Port Marine Notice

No. JDR/MN/19/2023

Subject : Ruwais and Yas Channel Enhancement – (Phase 1 - Dredging Yas Channel)

Project Name: JD Enhancement Project
 Phase No.: Phase I - Dredging Yas Channel
 Phase I Activity: Yas Channel Blockage for Traffic and ATN Arrangements

Phase 1 - Dredging Yas Channel

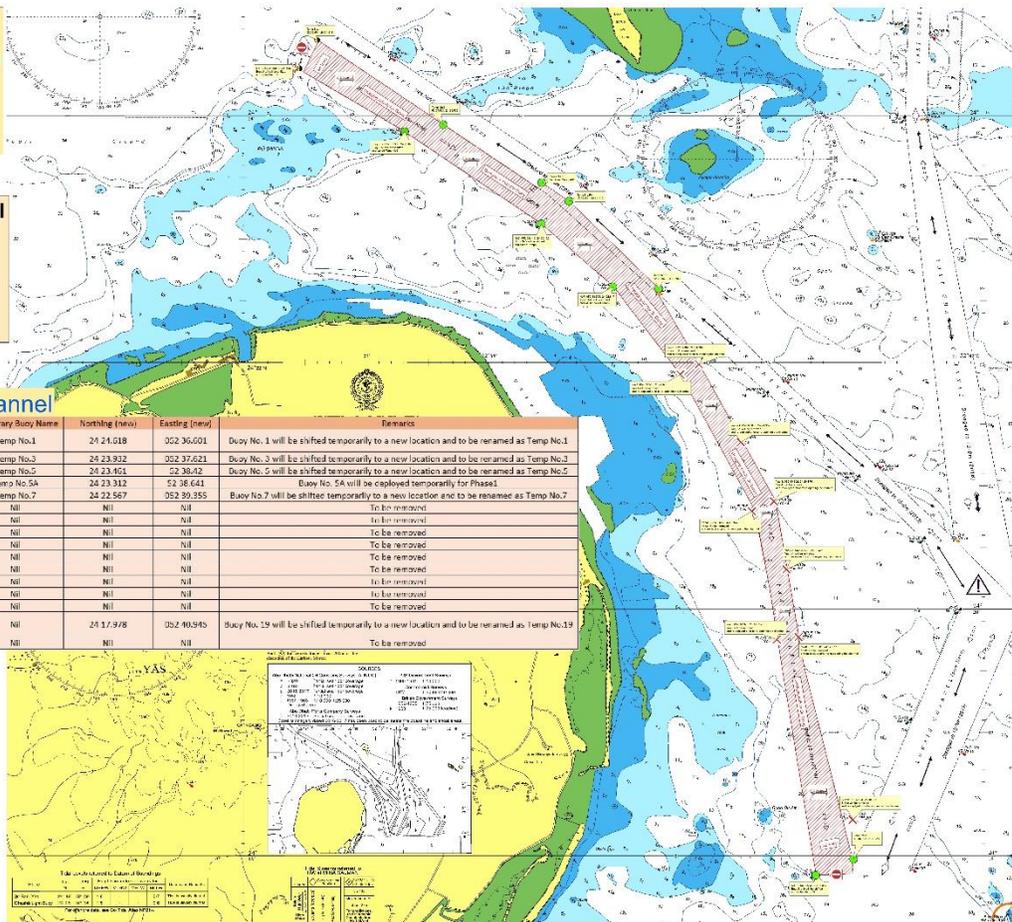
1. Yas Channel is closed till further notice and Re-location of Channel Buoys is done as per appended chart.
2. All vessels/crafts to proceed with minimum safe speed and navigate with extra caution, especially during dark hours.
3. Keep a sharp lookout for crossing traffic within navigating channels.
4. Maintain constant listening watch on Ch 21 and 09 .
5. All movements should be coordinated with Port Control/VTIS

S. No	Buoy Name	Northing (current)	Easting (current)	Temporary Buoy Name	Northing (new)	Easting (new)	Remarks
1	No.1	24 21.386	052 36.405	Temp No.1	24 24.018	052 36.601	Buoy No. 1 will be shifted temporarily to a new location and to be renamed as Temp No.1
2	No.3	24 22.876	052 37.308	Temp No.3	24 23.932	052 37.621	Buoy No. 3 will be shifted temporarily to a new location and to be renamed as Temp No.3
3	No.5	24 23.126	052 38.416	Temp No.5	24 23.861	052 38.512	Buoy No. 5 will be shifted temporarily to a new location and to be renamed as Temp No.5
4	Temp No.5A	Nil	Nil	Temp No.5A	24 23.312	052 38.641	Buoy No. 5A will be employed temporarily for Phase I
5	No.7	24 22.617	052 38.995	Temp No.7	24 22.567	052 39.355	Buoy No. 7 will be shifted temporarily to a new location and to be renamed as Temp No.7
6	M Yas	24 22.567	052 39.355	Nil	Nil	Nil	To be removed
7	Yas 1	24 21.936	052 39.561	Nil	Nil	Nil	To be removed

8	Yas 2	24 21.987	052 39.693	Nil	Nil	Nil	To be removed
9	Yas 2A	24 21.357	052 40.033	Nil	Nil	Nil	To be removed
10	Yas 3	24 20.796	052 40.123	Nil	Nil	Nil	To be removed
11	Yas 4	24 20.876	052 40.392	Nil	Nil	Nil	To be removed
12	Yas 4A	24 20.576	052 40.482	Nil	Nil	Nil	To be removed
13	Yas 5	24 19.157	052 40.325	Nil	Nil	Nil	To be removed
14	Yas 6	24 19.727	052 40.591	Nil	Nil	Nil	To be removed
15	No 19	24 17.847	052 40.670	Nil	24 17.978	052 40.940	Buoy No. 19 will be shifted temporarily to a new location and to be renamed as Temp No.19
16	S-Yas	24 18.236	052 40.040	Nil	Nil	Nil	To be removed
